MANDATORY SERVICE BULLETIN**REVISION RECORD**

Kodiak Flap Actuators

Electromech Flap Actuators (P/N 100-621-0100) within part serial number range 1659 through 1768

Figure 1: Flap Actuators

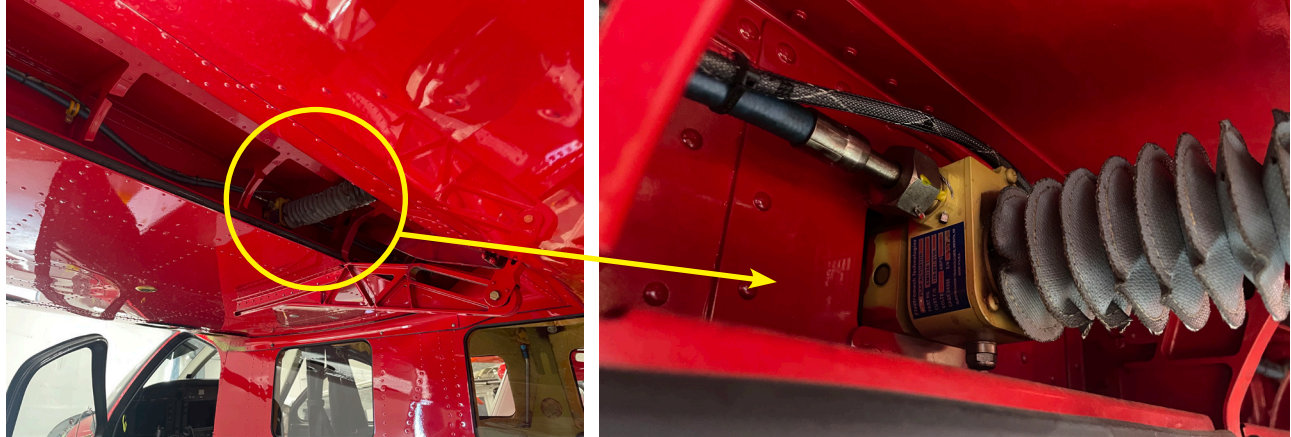
There are four (4) Flap Actuators installed on each Kodiak airplane, two (2) in each wing. The Flap Actuator part serial number is listed on a nameplate that is visible when the airplane flaps are in the full down position. See **Figure 1 - Flap Actuators**.

Inspect the Flap Actuators to verify the part serial numbers. Flap Actuators within the affected serial number range must be removed and replaced prior to further flight. Airplanes with Flap Actuators within the affected part serial number range are considered not airworthy. Contact Kodiak Care for further assistance.
